# **RANCHO SANTIAGO COMMUNITY COLLEGE DISTRICT**

## **ADDENDUM NO. 1**

**Bid # 1458 Fire Systems and Code Repairs Project  
at  
Santiago Canyon College**

**June 17, 2024**

F-002

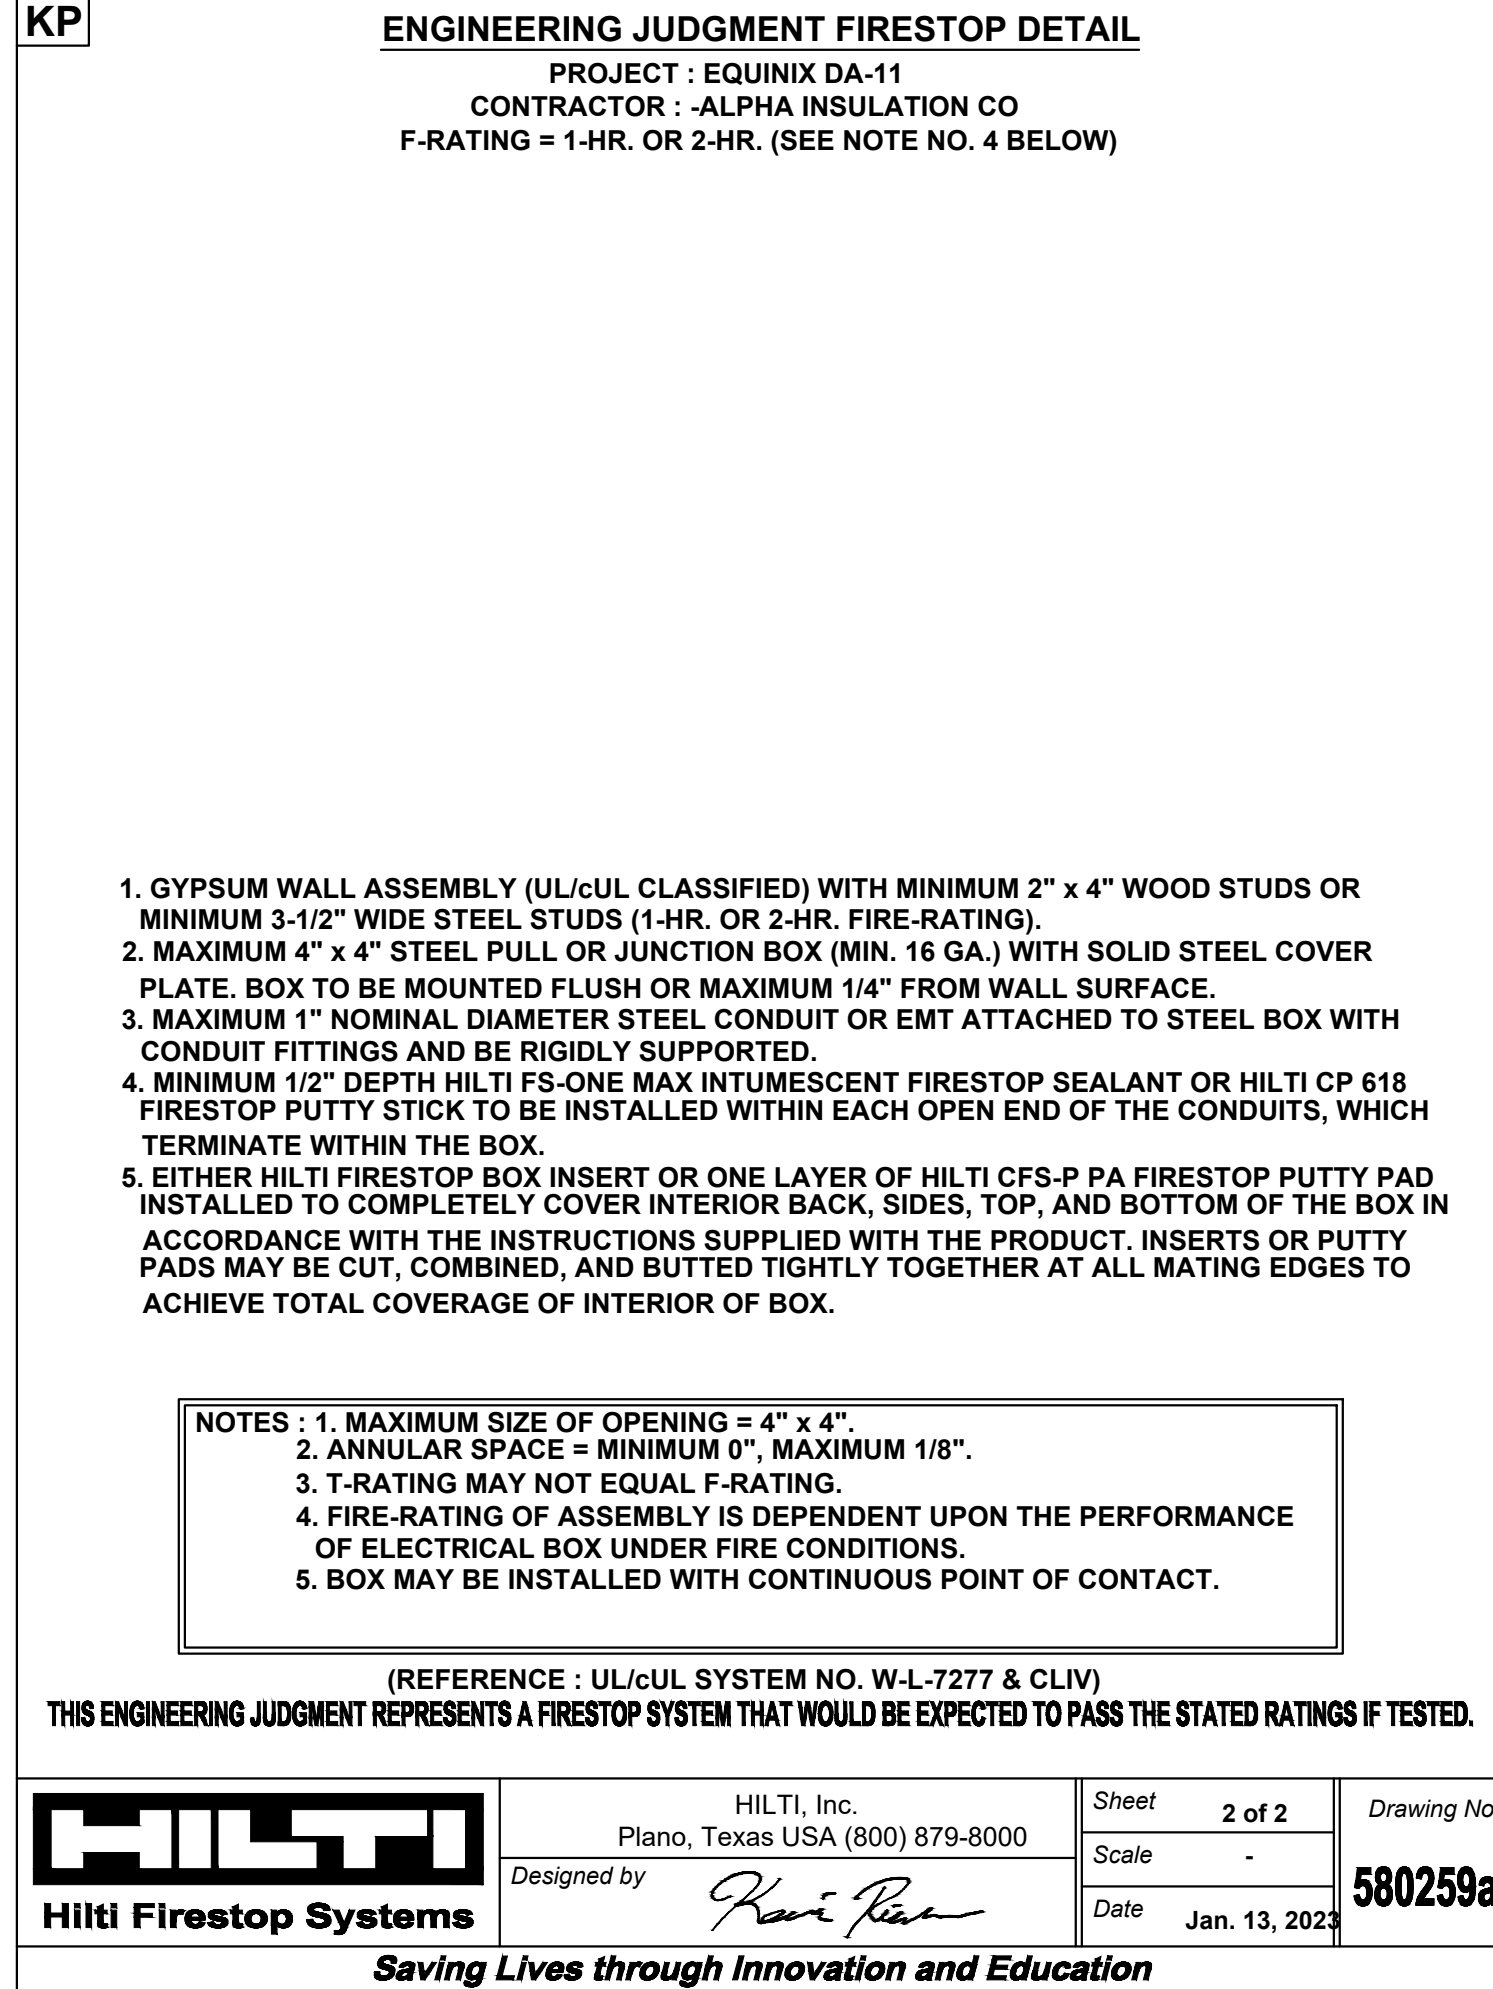
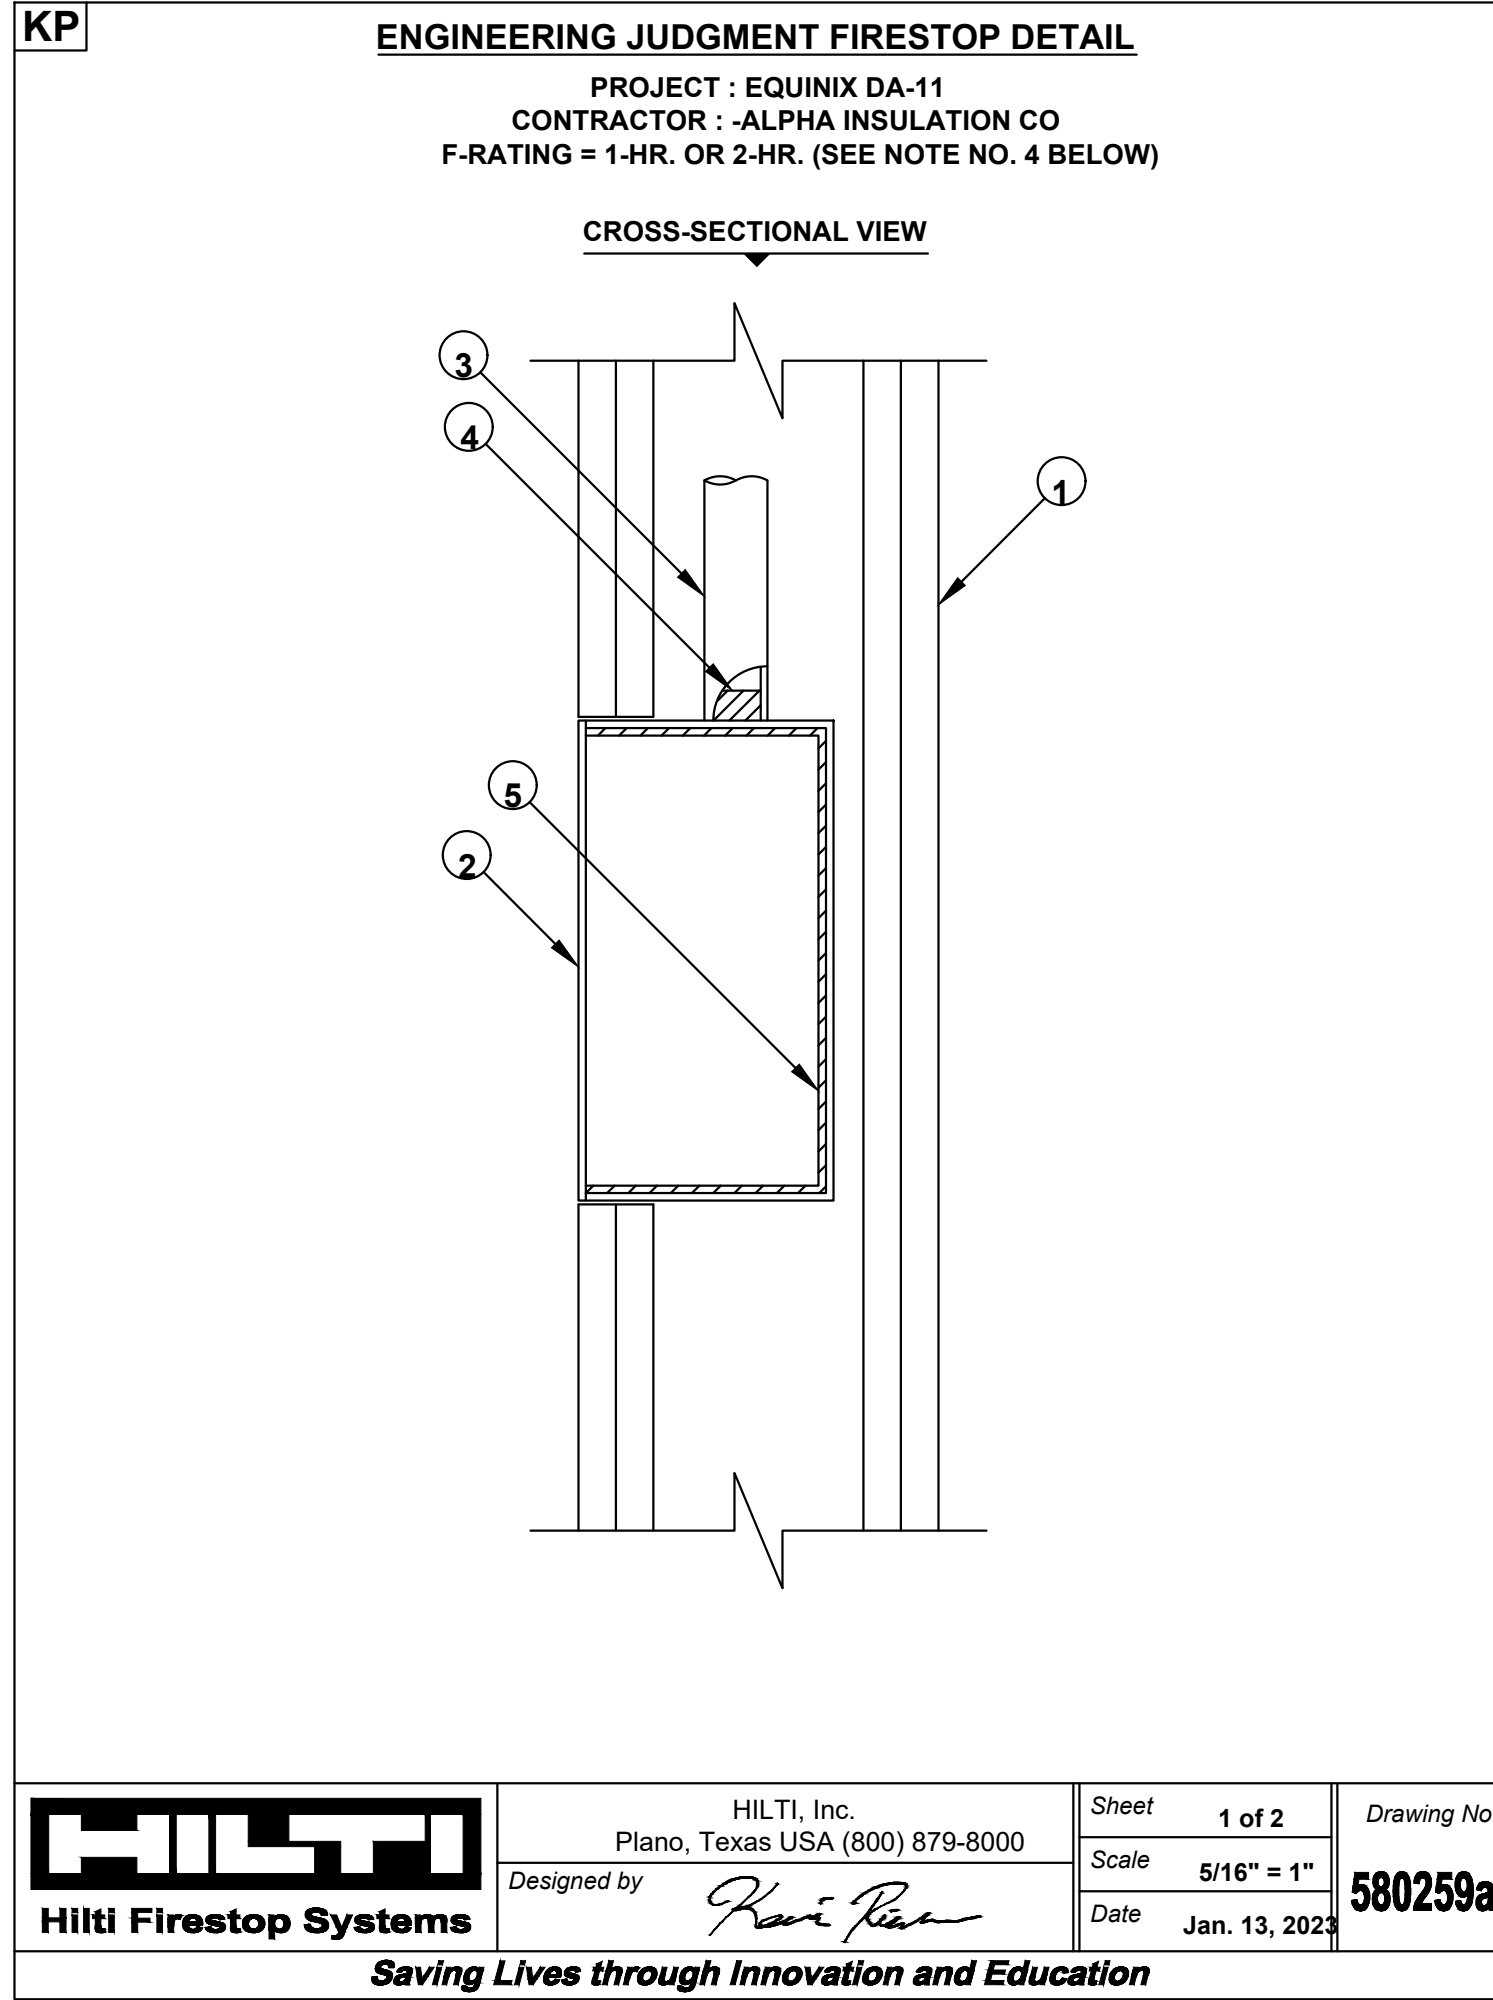
Drawings: Replace drawings F-002, F-603, and F-610 with their respective updated drawing sheets. See attached below.

- THROUGH-PENETRATIONS IN CONCRETE FLOORS/WALLS MAY BE PROTECTED WITH MINERAL WOOL AND FIRE SPRAY DETAIL 2F-610 AS AN ALTERNATIVE TO DETAIL 2F-603.
- THE CONTRACTOR SHALL SUBMIT PRODUCT DATA FOR ALL CONSTRUCTION MATERIALS REQUIRED WITHIN THE SCOPE OF WORK.
